Service Bulletin

Bulletin No.: 16-NA-168

Subject: Service Tip for Installing #4 Cross Bar Protective Caps When Replacing Fuel Tank

Brand:	Model:	Model Year:		VIN:		Engine:	Transmission:
		from	to	from	to		
Chevrolet	Volt	2016	2017

Involved Region or Country	North America and Korea
Condition	<div style="text-align: center; margin-bottom: 20px;"> ①  </div> <div style="text-align: center;"> ②  </div>
	4515969

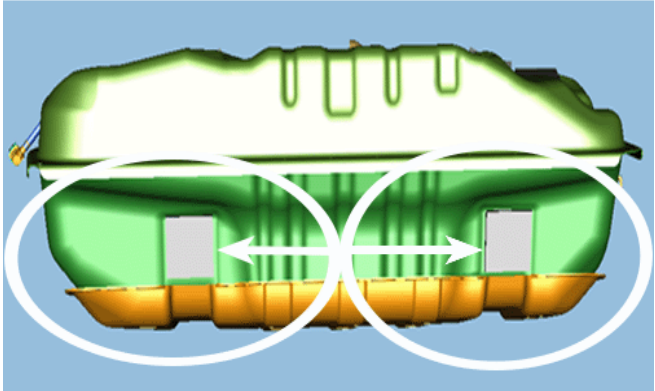
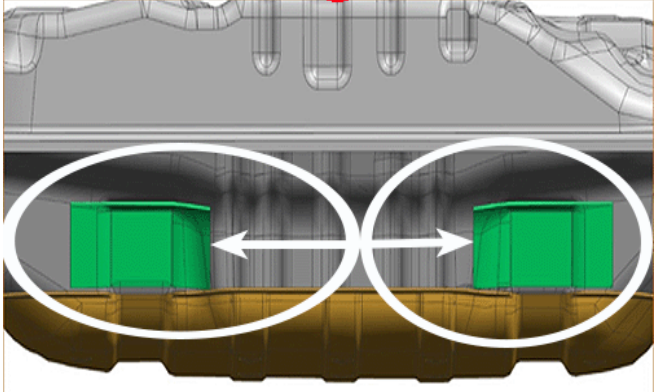
When servicing the fuel tank and/or replacing the isolator pads, the padding on the new design tank (1) is smaller than the current design (2) and requires the protective caps be installed to the #4 cross bar.

Note: The pads on the new design fuel tank are 62 mm wide, 62 mm tall and 8 mm thick.

Note: When replacing the #4 cross bar, inspect the padding on fuel tank to see which design tank is on the vehicle. If the vehicle has the current design (2) fuel tank, **NO** protective caps need to be installed. If the vehicle has the new design fuel tank (1), protective caps need to be installed to the #4 cross bar.

Correction

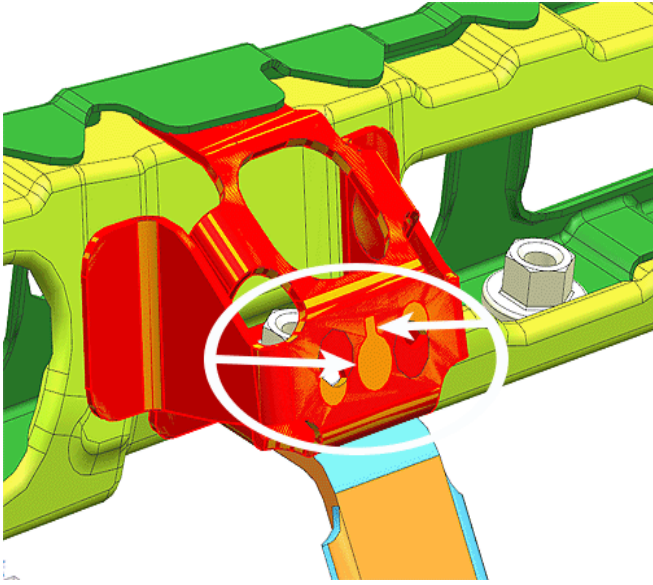
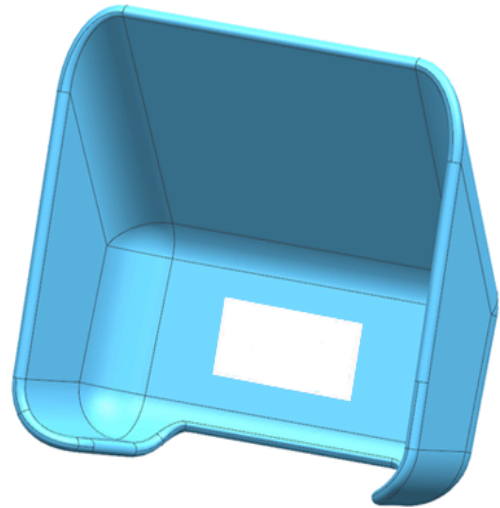
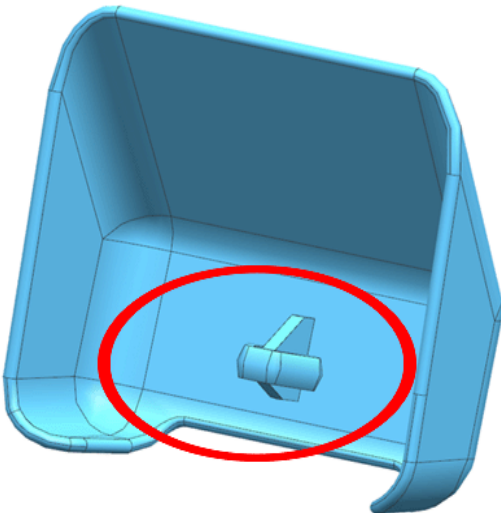
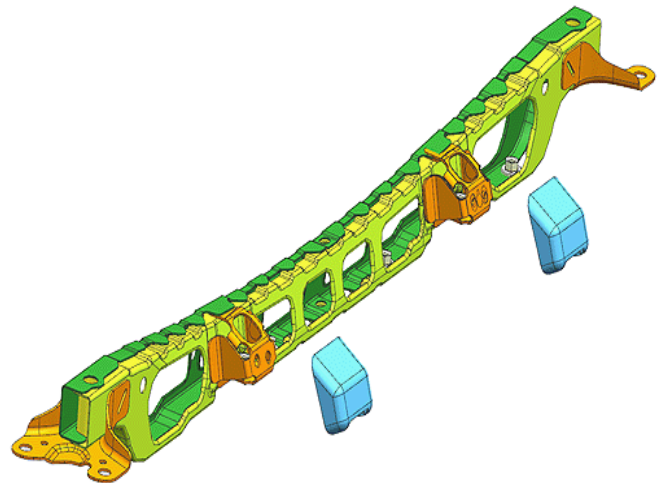
Before installing the caps, inspect the bracket on the #4 end cross bar for the HV battery for a key shaped hole. If the bracket doesn't come with the key shaped hole, grind off attaching feature on the back of the caps and retain them using double-sided tape.
